# Wylfa Newydd Project

## Horizon's Response to the ExA's Request for Further Information

PINS Reference Number: EN010007

10 April 2019

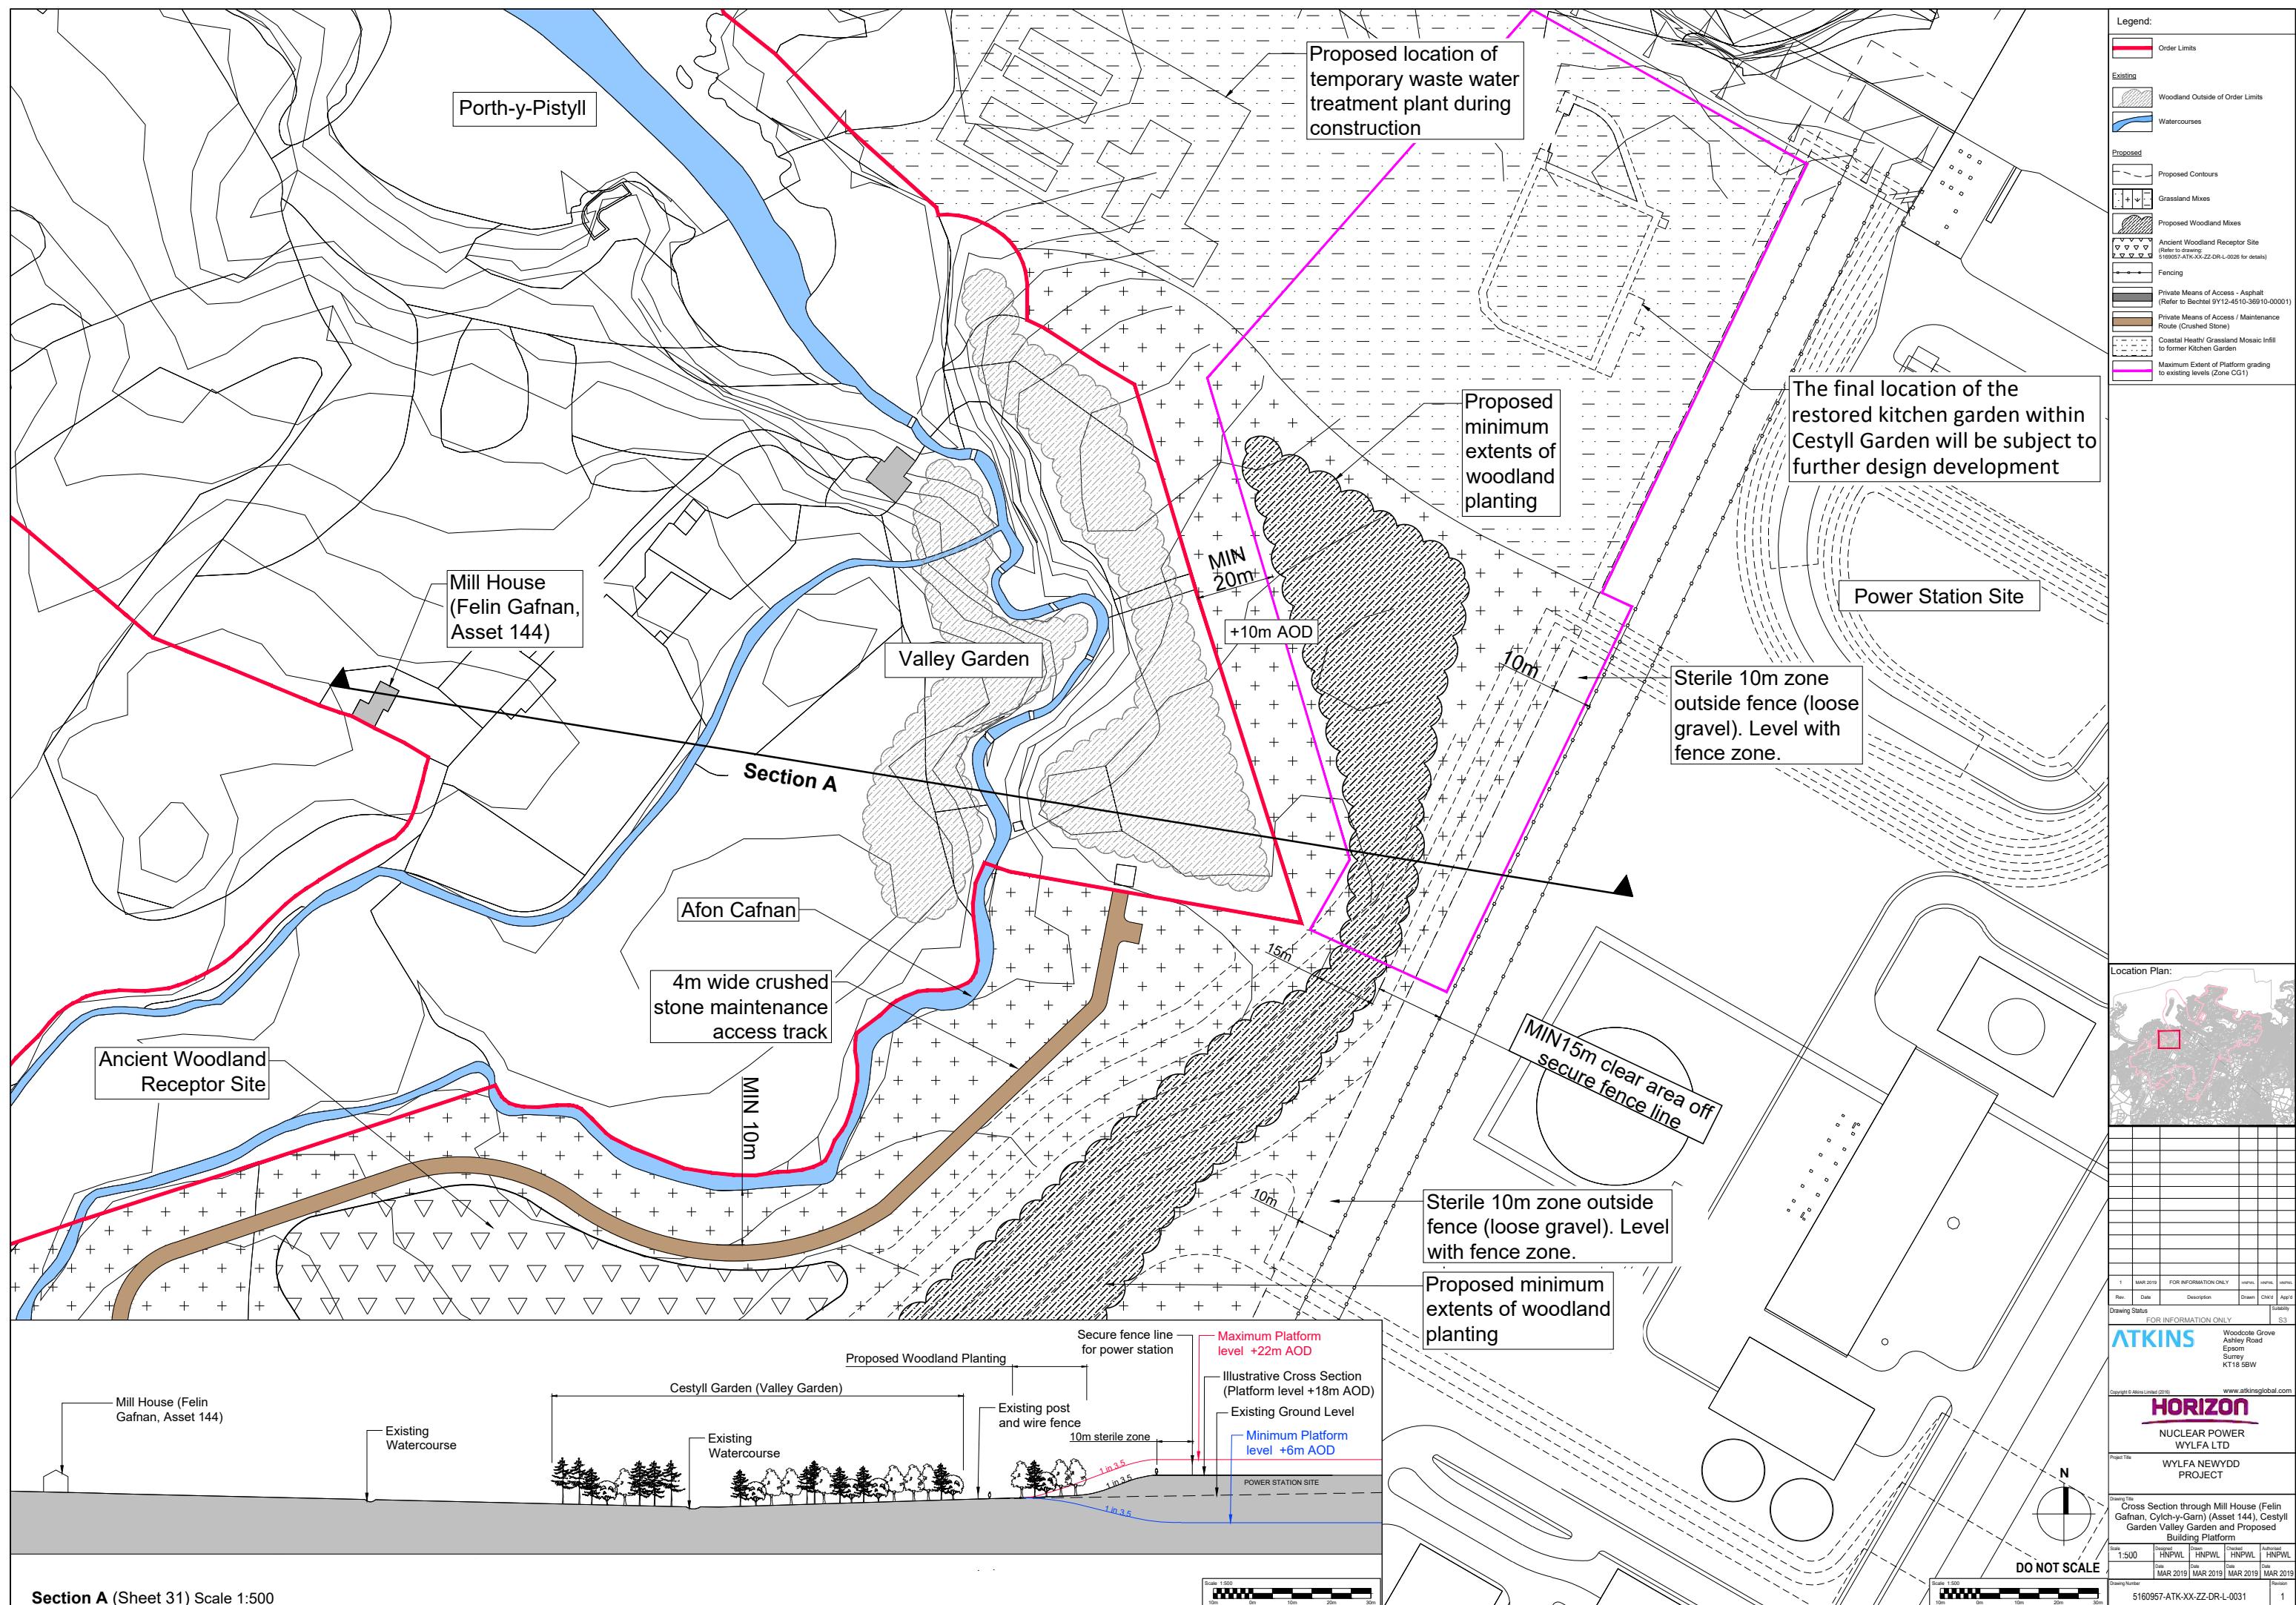
17.10.1 (g)	(g)The criticisms of previous responses in relation to the planning status of buildings of 9-201 and 9-202 in J Chanay's submission at D8 [REP8-078].	<p>J Chanay has submitted an array of confused and convoluted submissions seemingly in support of a desire that the Spent Fuel Storage Facility and Intermediate Level Waste Storage Facility are subject to separate TCPA applications. J Chanay clearly misunderstands the applicable regimes.</p> <p>These buildings are part of the NSIP because they are integral to the operation and decommissioning of the Power Station. The operation and decommissioning of the Power Station would result in the unavoidable generation of quantities of radioactive waste and spent fuel. At present there is no national disposal facility for higher activity radioactive waste (HAW) and spent fuel. A Geological Disposal Facility is planned for the disposal of spent fuel and HAW but this would not be available until 2040 at the earliest. Once available there would be a phased transfer of packaged waste from existing sites before Horizon would be able to access this facility for disposal of HAW and spent fuel. There is therefore a requirement to manage HAW and spent fuel on site</p>

Reference	Rule 17 Letter Question	Horizon's Response to Rule 17 Letter Question
		<p>in the intervening period. Further detail on these matters is set out in Appendix D14-1 - Radioactive waste [APP-233], and in Annex B to NPS EN-6.</p> <p>NPS EN-6 at 2.3.5 refers to the spent fuel and intermediate level waste stores as "key operational elements of the power station". Further, the functional relationship between the nuclear generating station and the waste buildings means that the nuclear generating station could not in practice be licensed or operate without the buildings.</p> <p>Whilst in theory there could be an offsite location, the Government's position for interim storage on site is set out in NPS EN-6. NPS EN-6 at 2.11.5 states that "in the absence of any proposal [for a GDF, the Planning Inspectorate] should expect that waste would be on site until the availability of a GDF." This assumption is re-iterated in Appendix B at B.4.2 and B.4.3.</p> <p>NPS EN-6 at para 2.11.5 envisages that such facilities could "either form part of the development of the NSIP or constitute 'associated development'. In terms of legal precedent, the Secretary of State in respect of the Hinkley Point C DCO included these facilities as part of the NSIP (see the Hinkley Point C (Nuclear Generating Station) Order 2013 Schedule 1, Work No. 1A, para (g)).</p> <p>J Chanay accuses Horizon of "inexplicably [ignoring] precedents to the contrary", going on to cite a 2003 decision on the construction of a new Intermediate Level Waste Store at Trawsfynydd Nuclear Power Station, made under the TCPA. That decision pre-dates the Planning Act 2008 regime. The Hinkley Point C DCO is the only relevant precedent.</p>
